April 17, 2025

**RE: REVISED PARKING STATEMENT FOR SMOKETREE RESORT MIXED-USE HOTEL: FEBRUARY 2025 SITE PLAN
— PARADISE VALLEY, ARIZONA**

Valet Parking Plan

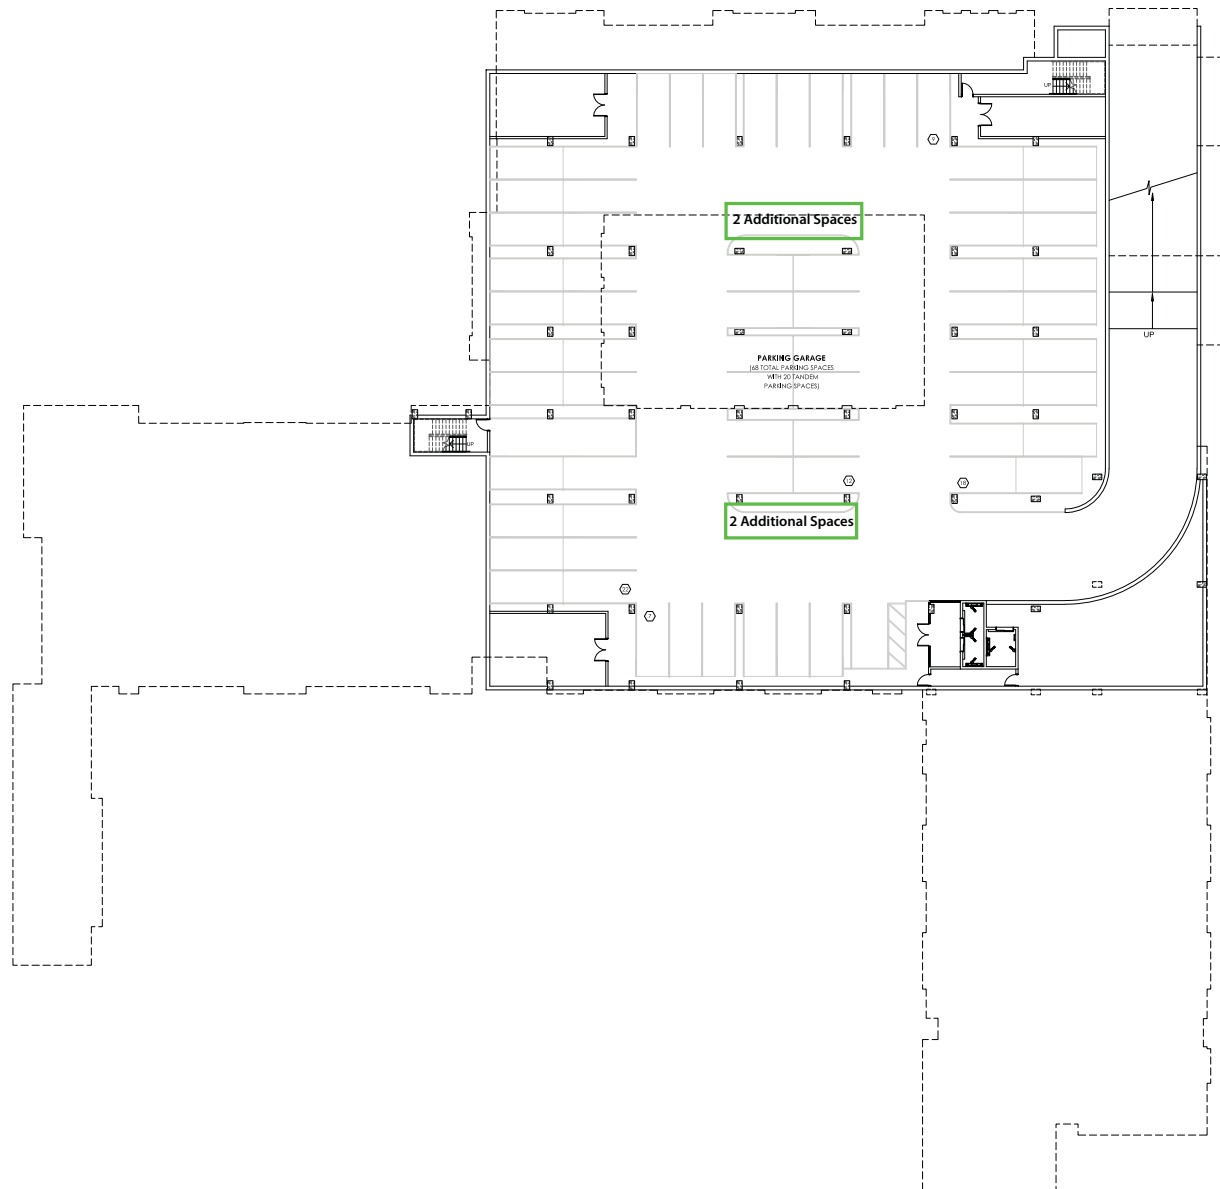
9.	Attachment H – Valet Plan states that 92 parking spaces can be provided in a Garage. Which parking garage is being referenced? Additionally, 6 spaces are provided in a loading zone area and 3 spaces are provided on what appears to be a sidewalk. Are there parking locations allowed? We suggest refining the valet plan to show viable parking spaces and the location of the referenced parking garage.	1. The location of the sub-grade parking has been clarified. The 3 spaces are around a parking lot. A straight line was used instead of a curved line.

9.	Attachment H – Valet Plan states that 92 parking spaces can be provided in a Garage. Which parking garage is being referenced? Additionally, 6 spaces are provided in a loading zone area and 3 spaces are provided on what appears to be a sidewalk. Are there parking locations allowed? We suggest refining the valet plan to show viable parking spaces and the location of the referenced parking garage.	1. The location of the sub-grade parking has been clarified. The 3 spaces are around a parking lot. A straight line was used instead of a curved line.

SITE PLAN

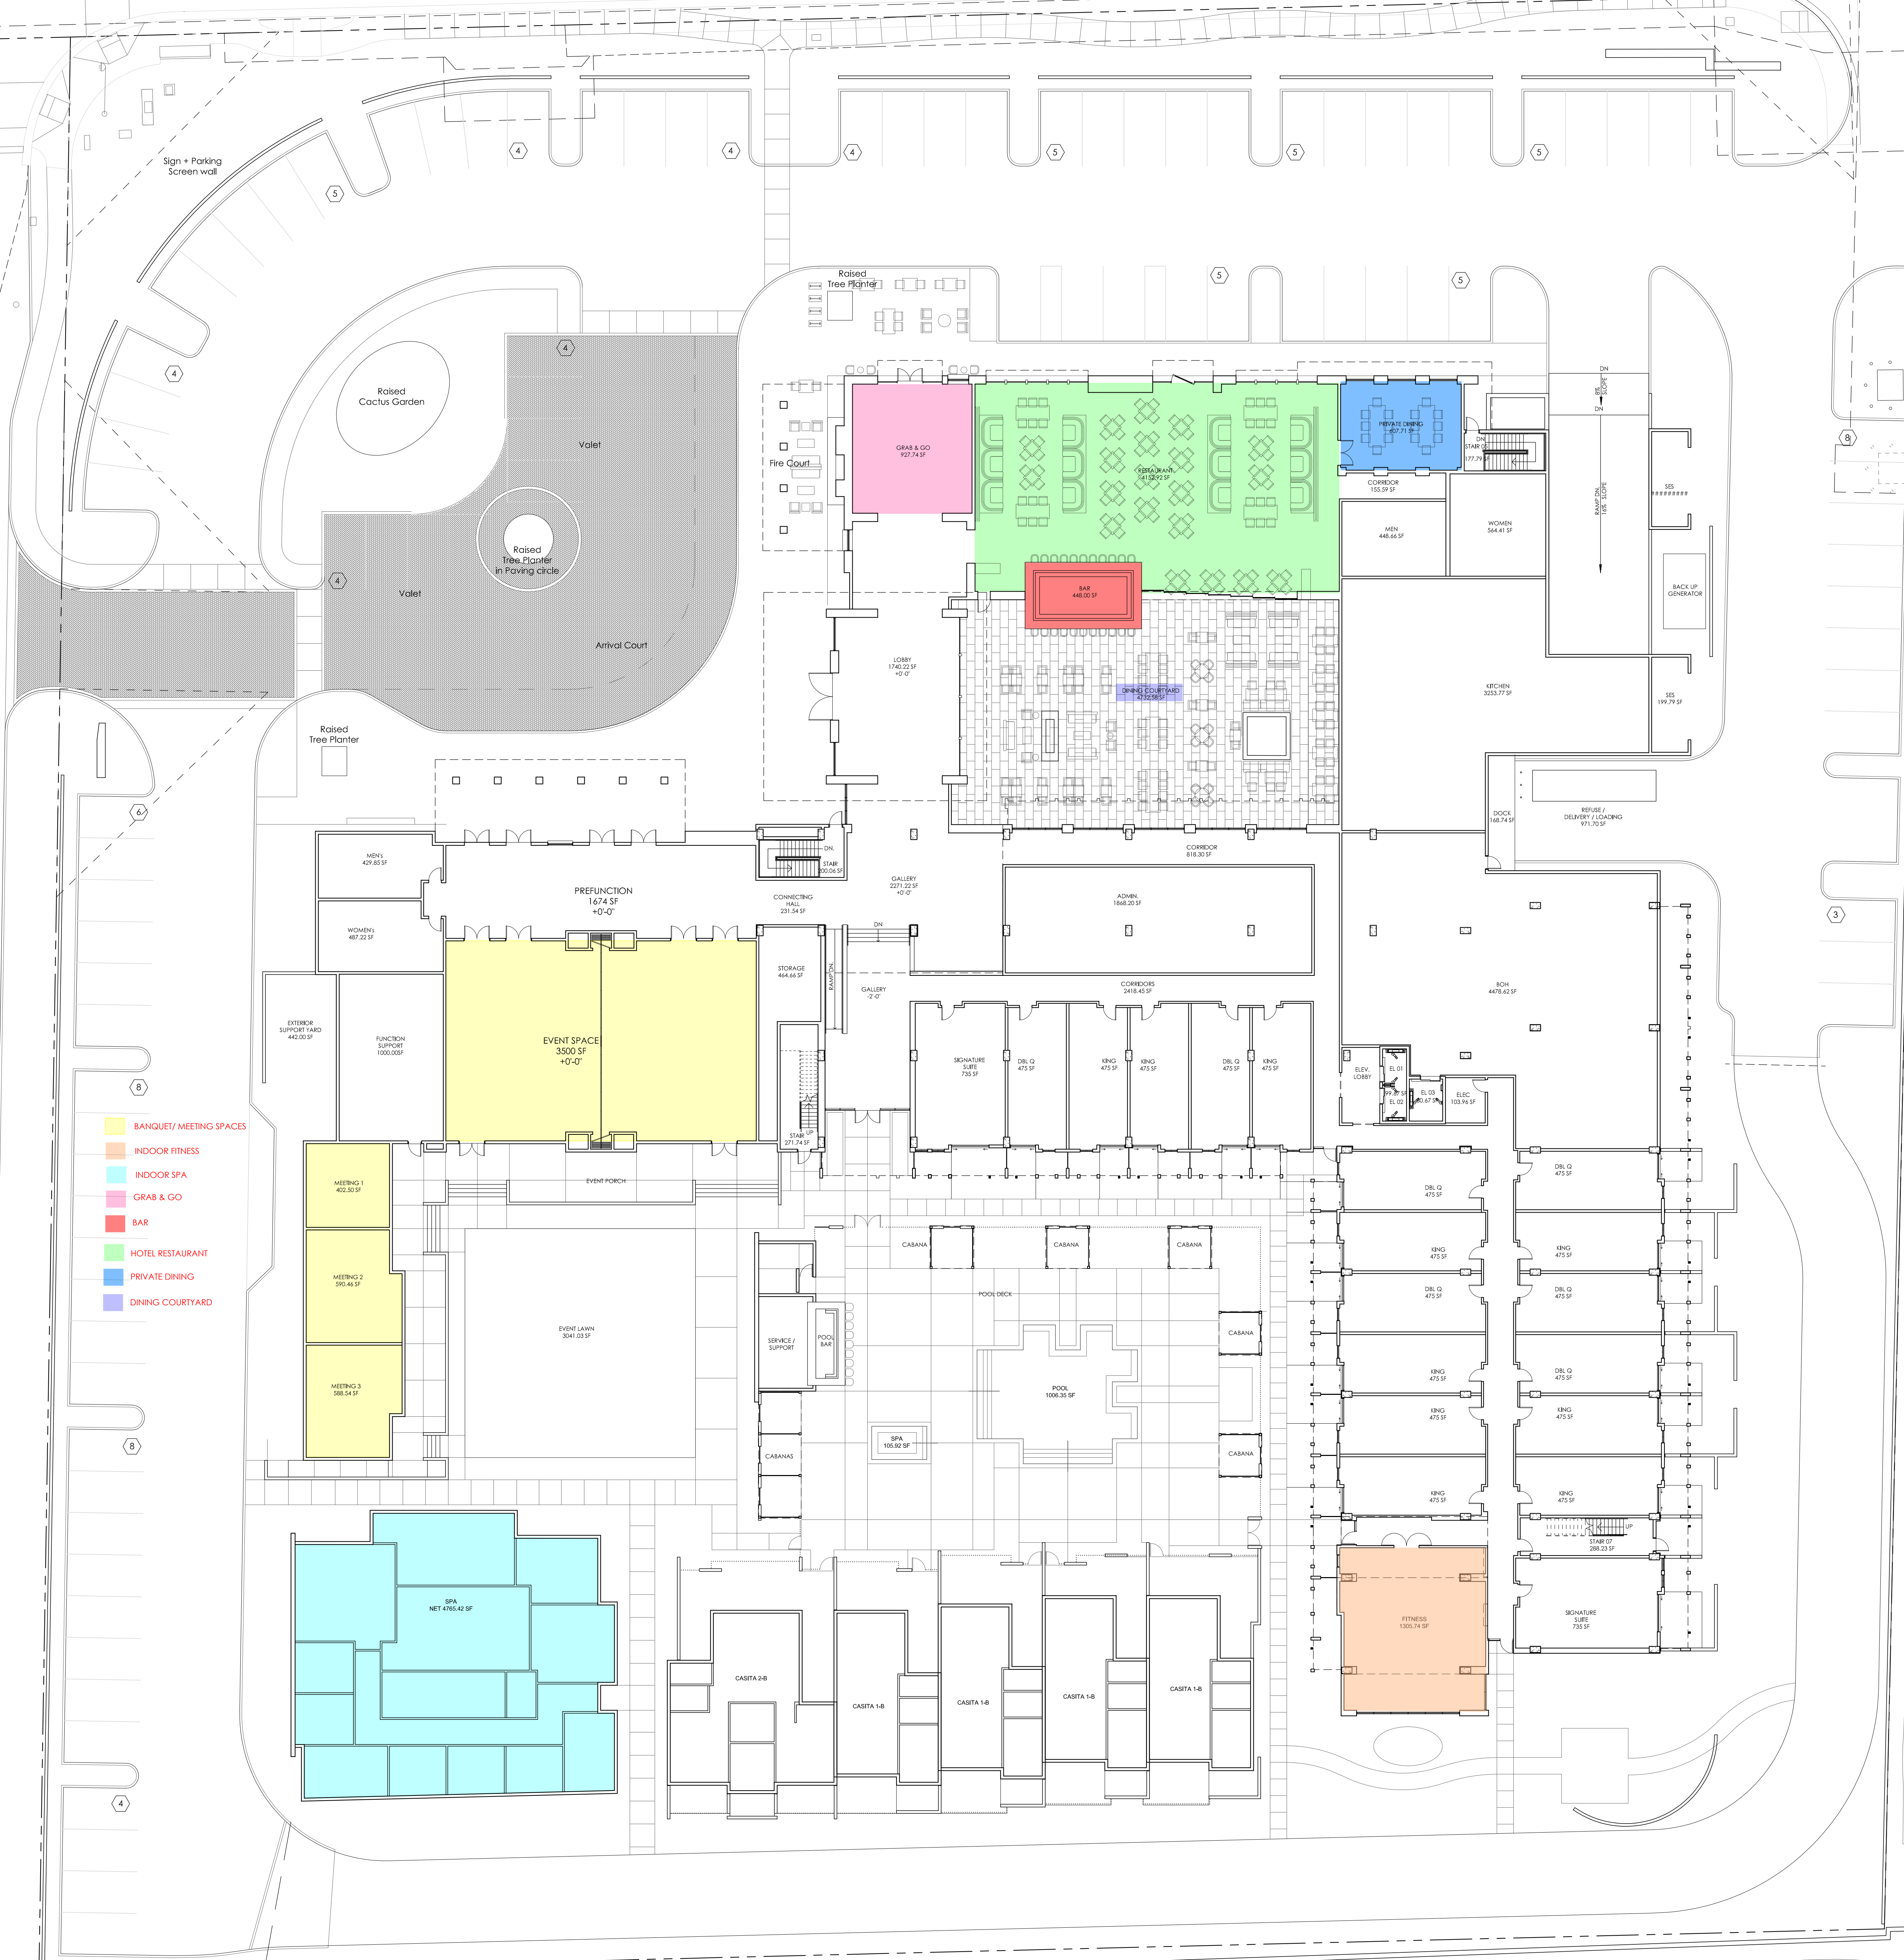
Item	Review Comment	(Code) & Response
4.	Page 19 – Attachment B Site Plan: The site plan and revised site plan detail a dining/courtyard of approximately 4,401 square feet with 116 seats. However, the shared parking study only evaluates the dining area inside the restaurant. The dining/courtyard is an extension of the restaurant’s dining area and should be included in the shared parking analysis. There is a scenario in which the interior and exterior dining areas are both at capacity. We suggest including the dining/courtyard square footage in the shared parking analysis.	(1) Analysis has been updated to include the outdoor dining area.

10.	Attachment B – Site Plan: Include a site plan for the valet operations. Where will the pick-up and drop-off zones be located? Additionally, what travel route will be used to drop vehicles off at available parking spaces? We suggest including a site plan for valet operations.	(1) A valet site plan is recommended and should be provided by the client.

Item	Review Comment	(Code) & Response
4.	Page 19 – Attachment B Site Plan: The site plan and revised site plan detail a dining/courtyard of approximately 4,401 square feet with 116 seats. However, the shared parking study only evaluates the dining area inside the restaurant. The dining/courtyard is an extension of the restaurant’s dining area and should be included in the shared parking analysis. There is a scenario in which the interior and exterior dining areas are both at capacity. We suggest including the dining/courtyard square footage in the shared parking analysis.	(1) Analysis has been updated to include the outdoor dining area.

10.	Attachment B – Site Plan: Include a site plan for the valet operations. Where will the pick-up and drop-off zones be located? Additionally, what travel route will be used to drop vehicles off at available parking spaces? We suggest including a site plan for valet operations.	(1) A valet site plan is recommended and should be provided by the client.
